<h2>Process Change Notice</h2>										Hirose Electric Co., Ltd.											
										Koriyama factory Quality control section											
										Approval	Review	Creation

Issue No. : PC-0007481

To: Hirose Electric Co., Ltd.		Your company name:	
Answer to the notification	Product name:	IX30G-A-10S-UNIT(10) (representative)	
	Content of change:	Change in lot marking method	
Approval for the change:		<div style="display: flex; justify-content: space-between;"> Approved Not approved With condition </div>	
Required materials for submission / other directions

Contents of change

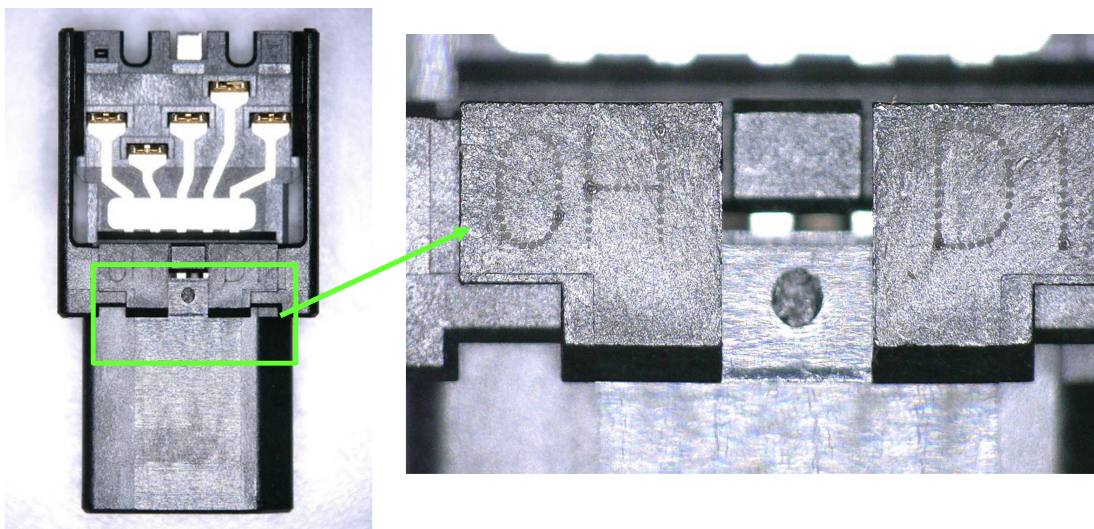
Before change (Hot stamp)

After change (laser marking)
